**URGENT Field Safety Notice**

**DigitalDiagnost C50 System**  
Telescopic Carriage Balance Issue

27-Feb-2023

Figure 1. Structure of telescopic carriage

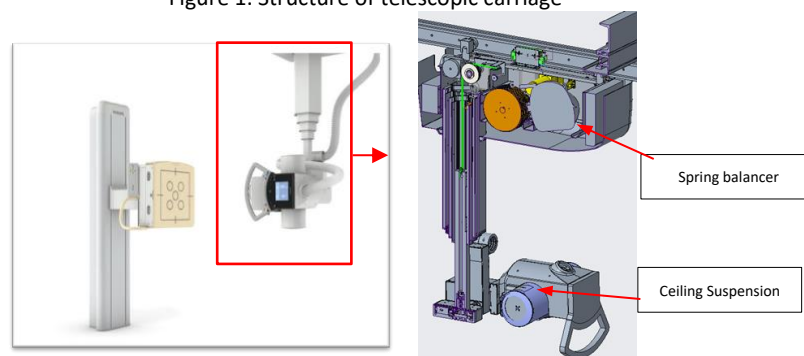
Philips has identified an issue that may occur with the DigitalDiagnost C50 system if Planned Maintenance (PM) is not completed as prescribed in the Instructions for Use (IFU). If the PM for the telescopic carriage is not performed annually as defined in the Instructions for Use (IFU), the tension force of the spring balancer inside of the telescopic carriage will unavoidably decay through normal wear and tear; as a result there is a potential that the Ceiling Suspension of the DigitalDiagnost C50 system may descend inadvertently if power to the system is interrupted, which may result in injuries to patients and users (Refer to figure 1).

- Follow the Planned Maintenance Program in the Addendum to the Instructions for Use in Appendix A of this notice for the safe use of your system(s).
- If the Ceiling Suspension is not able to be kept in its current position by itself and descends after the power to the system is off, contact your local Philips representative to perform the maintenance of the telescopic carriage.
- Place this *URGENT Field Safety Notice* with the documentation of your system(s).
- Complete the enclosed Customer Reply Form and send it back to confirm that users have reviewed and understood this *URGENT Field Safety Notice*.

**The planned maintenance for the Telescopic Carriage must be performed routinely every year, which is essential to keep sufficient counterbalance of CS (Ceiling Suspension). Insufficient counterbalance of CS could cause unexpected movement of CS, which may expose the patient to the hazardous situation of "Person trapped/squeezed between CS and other equipment", and may result in patient injuries, such as fracture(s), concussion, hematoma, contusion, bruise, pain, etc.**
